ARCHITECTURAL REVIEW BOARD STAFF REPORT

Project #/Name	ARB-2020-34: Valvoline Initial Site Plan
Review Type	Initial Site Plan/Preliminary Review of Architectural Design
Parcel Identification	04500-00-00-111C0
Location	East of 29 North, west of Gander Drive between Atlantic Union Bank and Goodwill
Zoned	Highway Commercial (HC), Entrance Corridor (EC)
Owner/Applicant	First Gold Leaf Land Trust / CESO (Kelly Schwieterman)
Magisterial District	Rio
Proposal	To construct a 2,080-sf oil change facility with associated site improvements on approximately .52 acres.
Context	The subject property is accessed by an internal road, Gander Drive, and is located within the Northtown Center development. Route 29 is largely characterized by commercial development with nearby developments including Rivanna Plaza across Route 29 to the west, Lowe's and Rio Hill Shopping Center to the southwest, Harbor Freight and Goodwill in the former Gander Mountain store to the south, and another phase of the Northtown Center to the southeast.

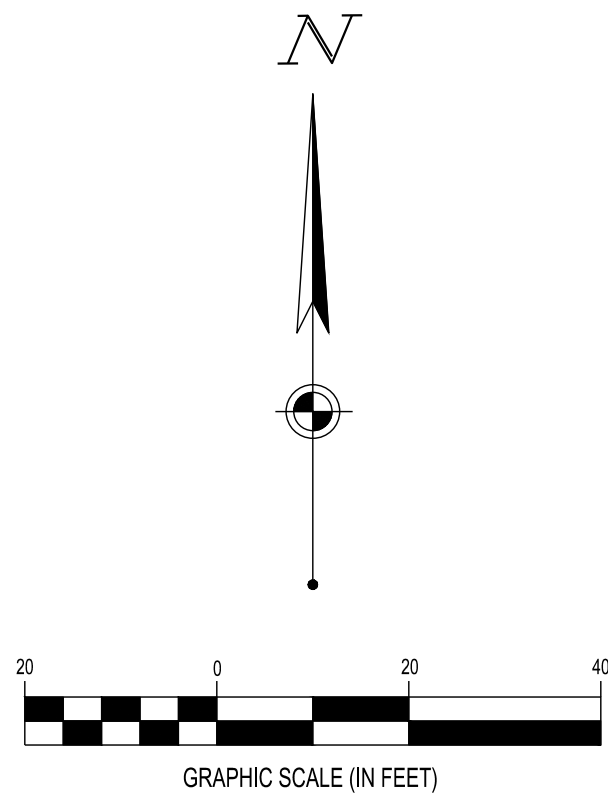
Lighting		
22	Light should be contained on the site and not spill over onto adjacent properties or streets;	The lighting does not exceed .5 foot-candles over any public roadways or adjacent properties.	None.
23	Light should be shielded, recessed or flush-mounted to eliminate glare. All fixtures with lamps emitting 3000 lumens or more must be full cutoff fixtures.	The proposed lighting is flush mounted. The proposed lamps emitting 3000 lumens or more are full cutoff.	None.
24	Light levels exceeding 30 foot-candles are not appropriate for display lots in the Entrance Corridors. Lower light levels will apply to most other uses in the Entrance Corridors.	The maximum proposed illumination at the ground is 6.8 fc, which is expected to have an appropriate appearance.	None.
25	Light should have the appearance of white light with a warm soft glow; however, a consistent appearance throughout a site or development is required. Consequently, if existing lamps that emit non-white light are to remain, new lamps may be required to match them.	The proposed fixtures do not have a consistent color temperature. The pole-mounted fixtures have a color temperature approximating white daylight (5k) while the wall-mounted fixtures have a color temperature of soft, warm white (3k).	Revise the pole-mounted fixtures to soft, warm white (3k).

27	The height and scale of freestanding, pole-mounted light fixtures should be compatible with the height and scale of the buildings and the sites they are illuminating, and with the use of the site. Typically, the height of freestanding pole-mounted light fixtures in the Entrance Corridors should not exceed 20 feet, including the base. Fixtures that exceed 20 feet in height will typically require additional screening to achieve an appropriate appearance from the Entrance Corridor.	The height of the proposed pole-mounted lights does not exceed 20'. However, it is unclear if this includes the base. The architectural plans indicate two types of wall lights; however, only one cutsheet was provided. The photometric plan includes proposed lights with an LLF (maintenance factor) of less than 1.0 (0.855). This should be revised to 1.0.	Include a note on the lighting plan indicating that the 20' maximum height of the pole-mounted light fixtures includes any base. Revise the lighting plan to include cut sheets for all wall lights. Revise lights with an LLF (maintenance factor) of less than 1.0 to 1.0.

9. Revise the pole-mounted fixtures to soft, warm white (3k).
10. Include a note on the lighting plan indicating that the 20’ maximum height of the pole-mounted light fixtures includes any base.

11. Revise the lighting plan to include cut sheets for all wall lights.
12. Revise lights with an LLF (maintenance factor) of less than 1.0 to 1.0.
13. Add the standard lighting note to the lighting plan.

LANDSCAPE PLAN

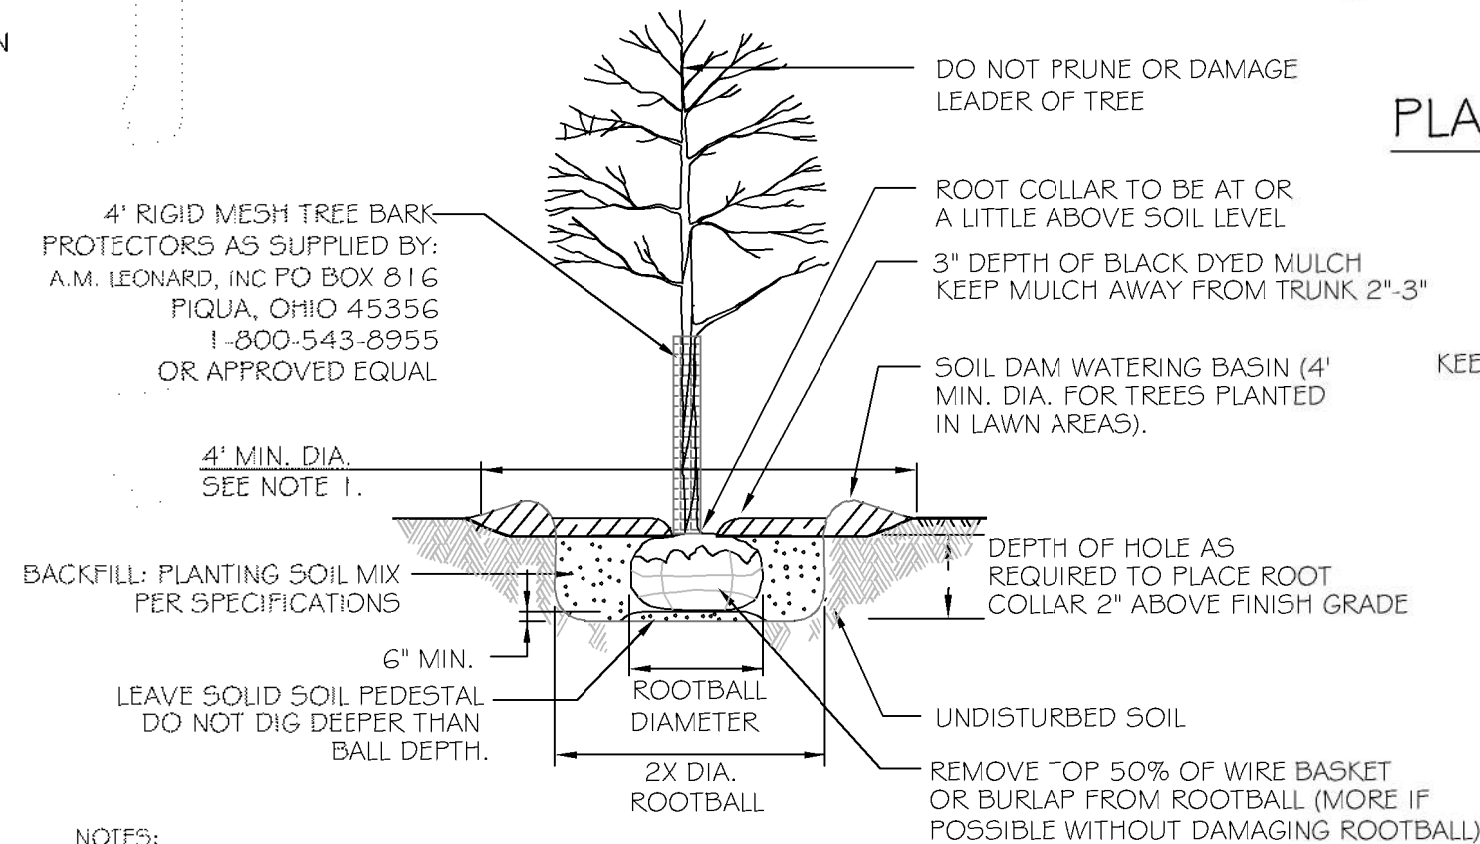
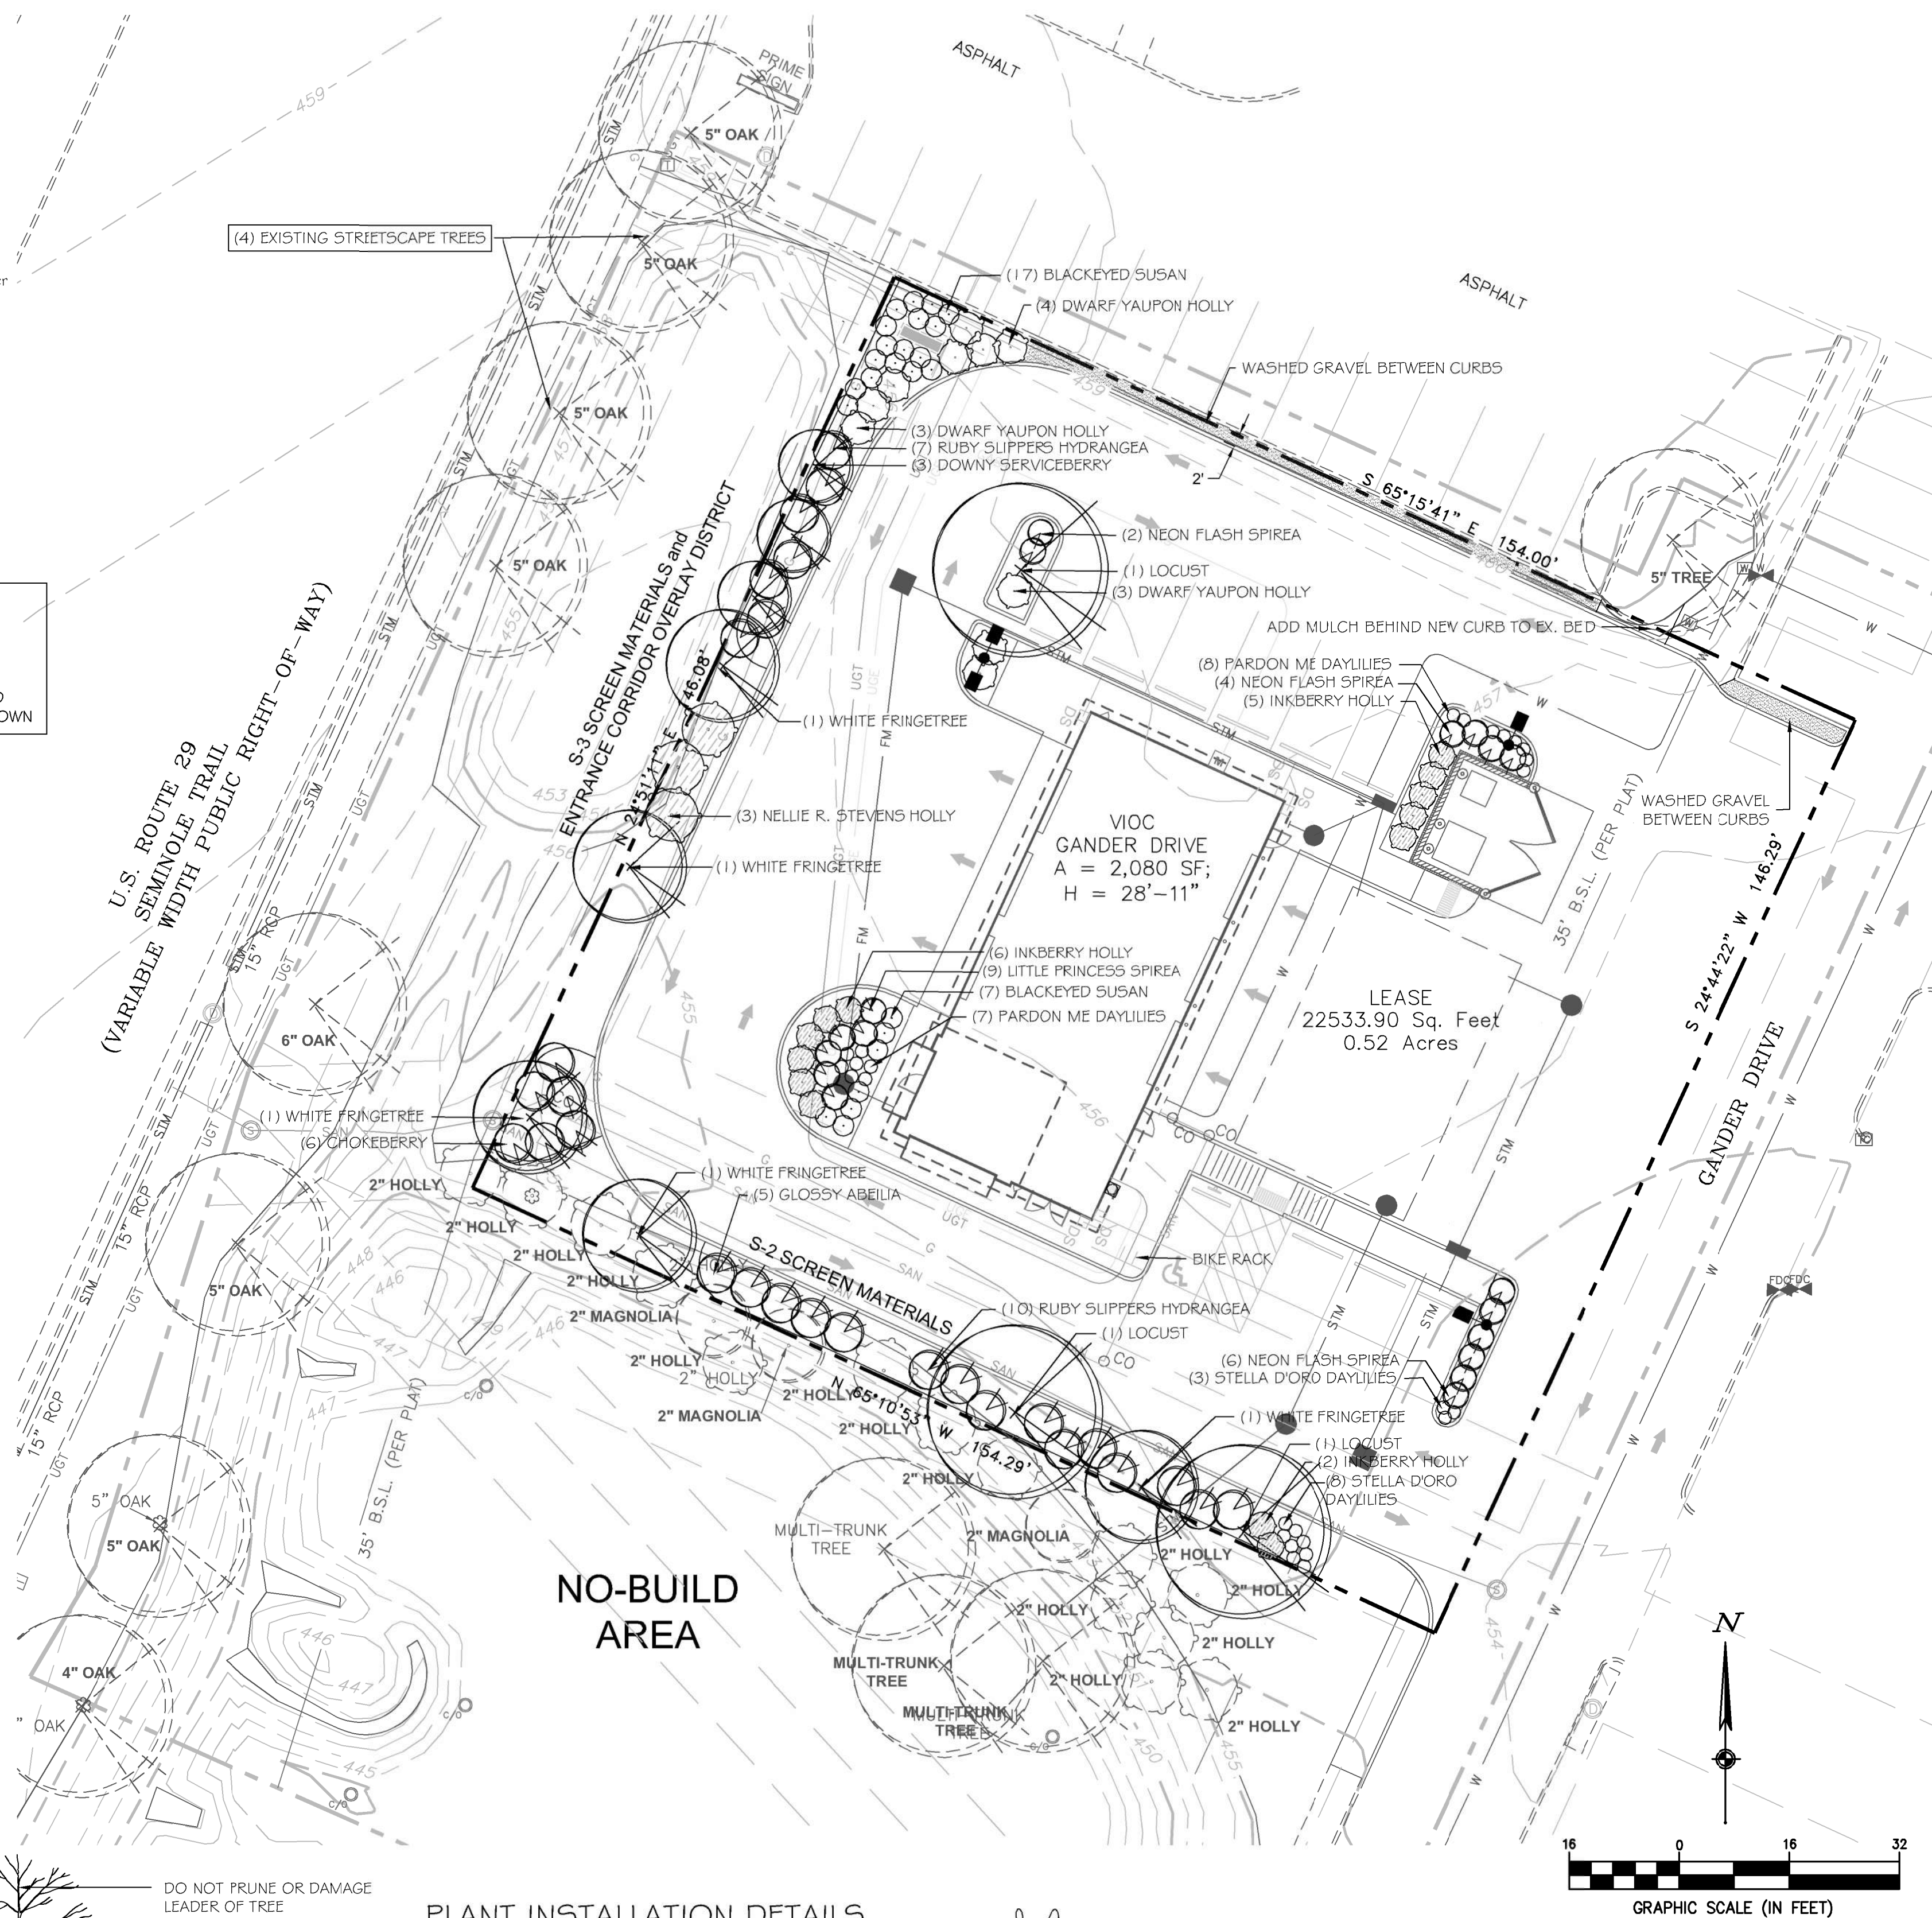
28	In determining the appropriateness of lighting fixtures for the Entrance Corridors, the individual context of the site will be taken into consideration on a case by case basis.		
29	The following note should be included on the lighting plan: "Each outdoor luminaire equipped with a lamp that emits 3,000 or more initial lumens shall be a full cutoff luminaire and shall be arranged or shielded to reflect light away from adjoining residential districts and away from adjacent roads. The spillover of lighting from luminaires onto public roads and property in residential or rural areas zoning districts shall not exceed one half footcandle."	The note is not present on the lighting plan.	Add the standard lighting note to the lighting plan.
30-31	Guidelines for the Use of Decorative Landscape Lighting	There is no decorative landscape lighting proposed for the site.	None.
	Landscaping		
7	The requirements of the Guidelines regarding landscaping are intended to reflect the landscaping characteristic of many of the area's significant historic sites which is characterized by large shade trees and lawns. Landscaping should promote visual order within the Entrance Corridor and help to integrate buildings into the existing environment of the corridor.	Street frontage along this stretch of the EC is characterized by primarily large shade trees with interspersed ornamental trees. There are existing large shade trees (5) planted along the frontage of the EC. The existing trees range from 4" – 6" caliper and are spaced between 17' and 69' on center. The existing quantity of trees meets the requirement; however, spacing exceeds 35' in some places. In addition, there are no ornamental trees existing along the frontage or proposed	Revise the landscape plan to show interspersed ornamentals trees along the EC.

35	Landscaping of parking areas: a. Large trees should align the perimeter of parking areas, located 40 feet on center. Trees should be planted in the	Three large shade trees are proposed along the western perimeter of the paved area. This satisfies the required quantity of trees;	Revise the landscape plan to include additional planting in the gap along

interior of parking areas at the rate of one tree for every 10 parking spaces provided and should be evenly distributed throughout the interior of the parking area. b. Trees required by the preceding paragraph should measure 2½ inches caliper (measured six inches above the ground); should be evenly spaced; and should be of a species common to the area. Such trees should be planted in planters or medians sufficiently large to maintain the health of the tree and shall be protected by curbing. c. Shrubs should be provided as necessary to minimize the parking area's impact on Entrance Corridor streets. Shrubs should measure 24 inches in height.	however, the spacing is irregular, leaving a gap aligned with the entrance tower. Additional landscaping should be provided to fill the gap and provide a consistent appearance. The proposed shrubs along the perimeter of the parking area are 24" - 30" in height. The south perimeter of the parking area has the required number of trees; however, the spacing is irregular. This spacing accommodates existing trees located outside the project area along the southern boundary of the lease area, which help to screen the paved areas of the site. Three trees are required along the northern perimeter of the parking area, but none are proposed. There are ten parking spaces proposed. This requires one interior tree, which has been proposed. At 2" caliper, the proposed interior and perimeter trees are smaller than the requirement.	the western perimeter of the paved area. None. None. Revise the landscape plan to show large shade trees at 40' on center and 2.5" caliper along the northern perimeter of the parking area. None. Revise the caliper of the proposed interior and perimeter parking trees to the required 2.5".

36	Landscaping of buildings and other structures: a. Trees or other vegetation should be planted along the	There is a planting bed proposed along the west end of the building in front of the	Revise the landscaping proposed to shrubs that

14. Revise the landscape plan to show interspersed ornamentals trees along the EC.
15. Revise the landscape plan to include additional planting in the gap along the western perimeter of the paved area.

16. Revise the landscape plan to show large shade trees at 40’ on center and 2.5” caliper along the northern perimeter of the parking area.
17. Revise the caliper of the proposed interior and perimeter parking trees to the required 2.5”.

18. Revise the landscaping proposed to shrubs that are at least 24” in height.
19. Add the standard landscaping note to the landscape plan.
20. Show existing trees on the existing conditions plan.
